**PRE-APPLICATION CONFERENCE  
 Asa's View (2022-003-PAC)**

Meeting conducted on February 2, 2022 at 11:00 AM PST

Site Address	2313 NE Lockwood Creek Road
Legal Description	#102 and #39 of Section 2, T4N R1E WM
Applicant	Troy Johns (360) 600-4425 <a href="mailto:Troy@urbannw.com">Troy@urbannw.com</a> 1004 W. 13 <sup>th</sup> Street. St. Suite 220 Vancouver, WA 98660
Applicant's Representative	Shawn Ellis NW Consillo LLC (503) 415-0424 <a href="mailto:Sellispdx@gmail.com">Sellispdx@gmail.com</a> 2410 NE 22 <sup>nd</sup> Avenue, Portland, OR 97212
Property Owner	William Roskowski Gravitare Capital LLC (503) 201-1208 <a href="mailto:William@roskowski.com">William@roskowski.com</a> 13563 NW Fuller Road, Portland, OR 97229
Proposal	Subdivide 16.56 acres into 71 single-family residential lots in the LDR 7.5 zone
Date of Issue	10 February, 2022

**C505**

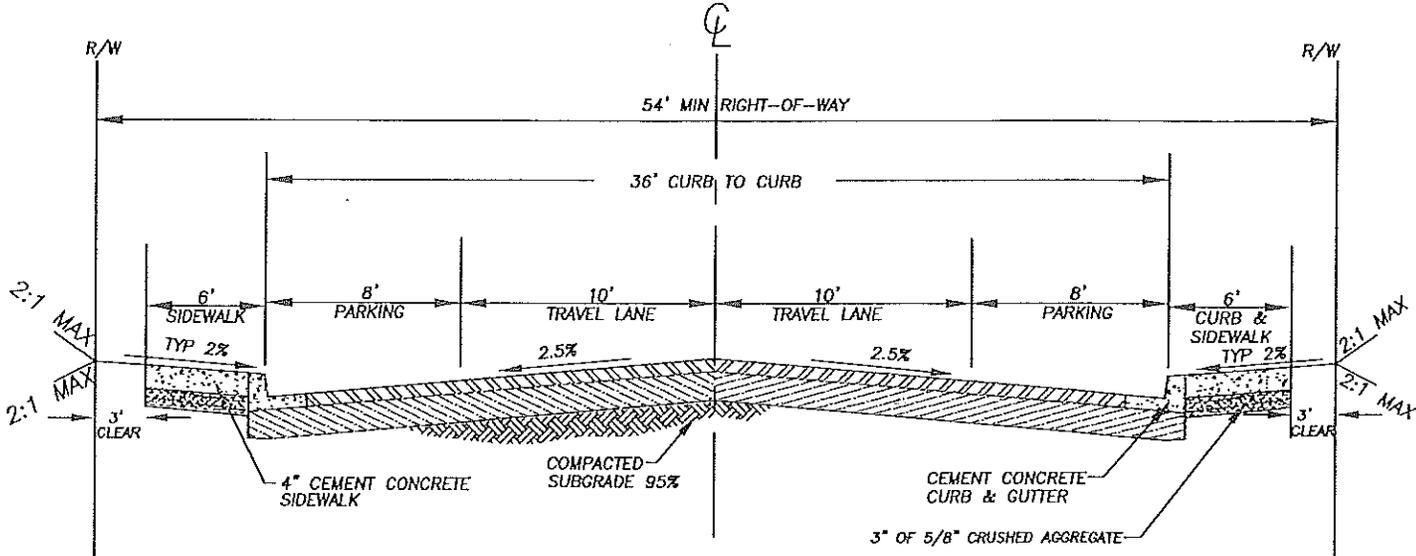
The applicant is proposing to connect the sanitary sewer piping to the existing Middle School pump station. An 8-inch pipe stub was provided to the east school property line from the pump station wet well for future connection to the parcels east of the school property. A public sewer main is shown on the preliminary plans for Asa's that traverses through the development lots. A minimum of a 15-

feet wide public easement will need to be provided on private property with vehicle access to the easement. **See Attachment A.**

# NEIGHBORHOOD ACCESS

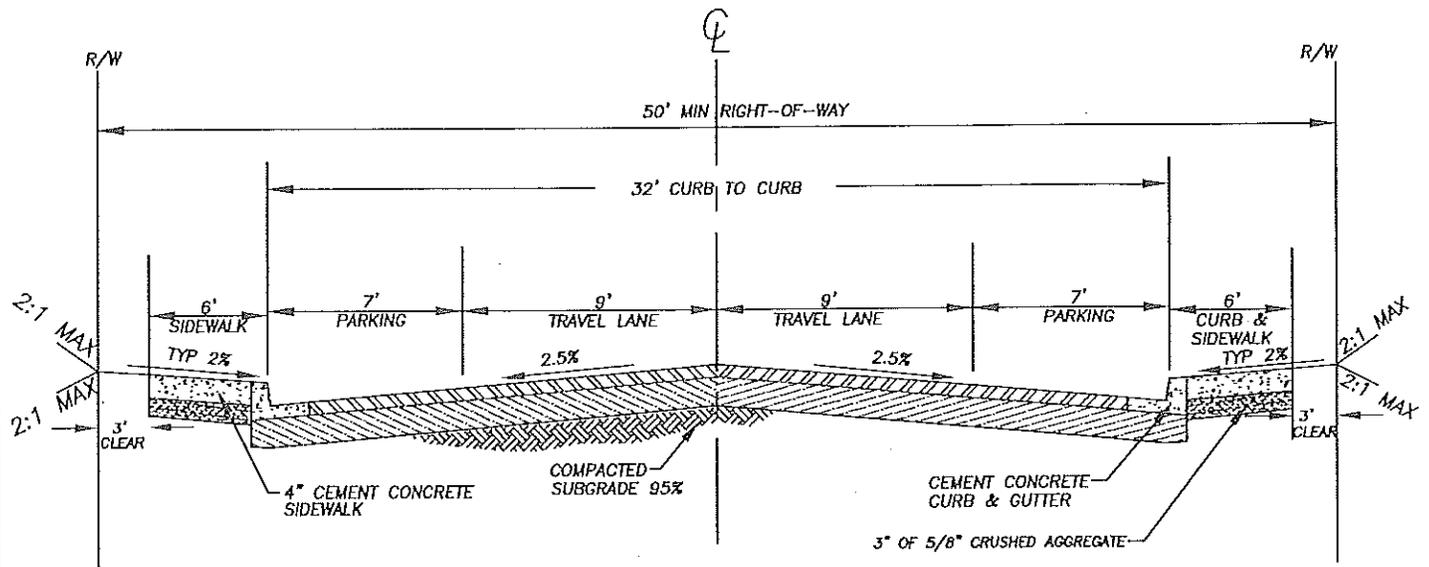
Half street improvements will need to be constructed along the frontage improvements for a plat per the Minor Arterial "A" Standard Detail. The streets within the development shall be either a Neighborhood or Local Street Standard per the Engineering Standards depending on the ADT,

**MINOR ARTERIAL "A"**

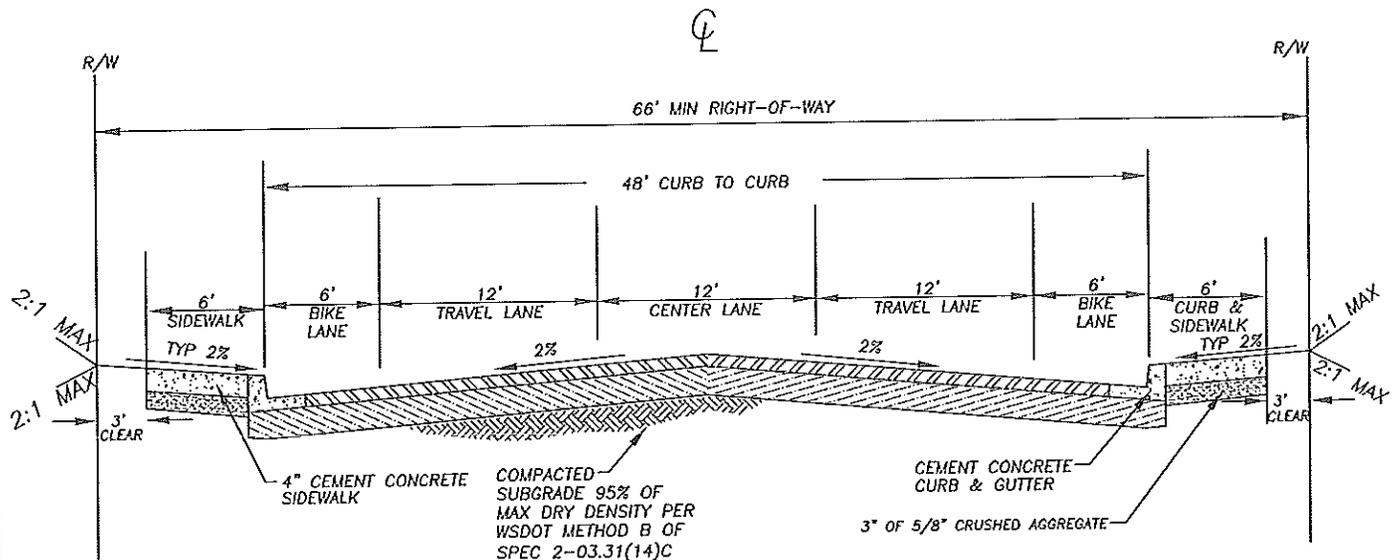
Lockwood Creek Road is classified as a Minor Arterial per the updated Capital Facilities Plan. The city has designated Lockwood Creek Road as a Minor Arterial "A" per the Engineering Standards. General roadway and right-of-way standards shall apply and provide half street improvements per LCMC 12.10.090.
